# Authorized Field Change

AFC G-07909

**Subject:** Leaking Fuel Line on VT 275 Engines

Model: W42

Remove banjo bolt from right  
head

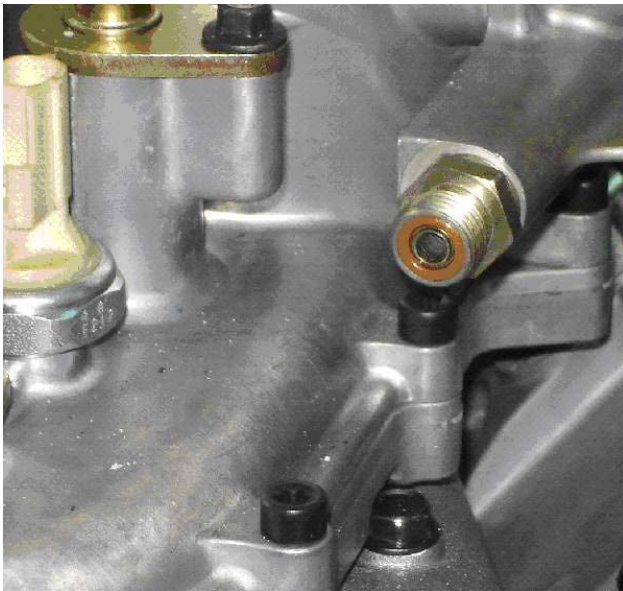
3. Remove banjo bolt from right cylinder head and discard copper seals.

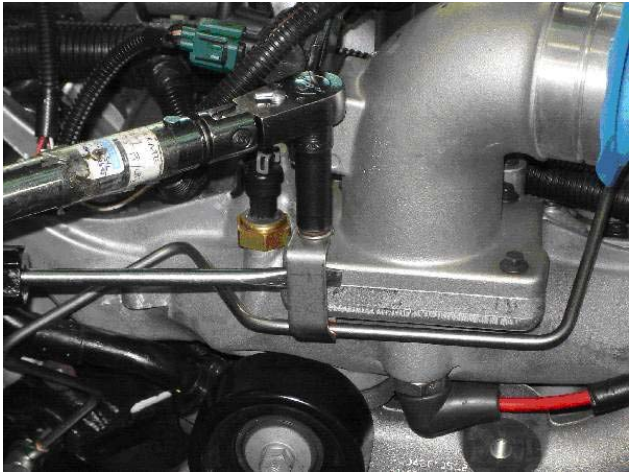
7. Install fuel line so the support bracket is located between the two washers.
8. Install new copper seals (included in kit) on banjo bolt and install hand tight.
9. Install fuel line to the fuel filter housing and hand tighten.
10. Torque banjo bolt to 38 Nm (28 lbf-ft) while holding screwdriver between banjo fitting and tabs on head.

**NOTE – Make sure screwdriver is on banjo fitting and not on fuel line.**
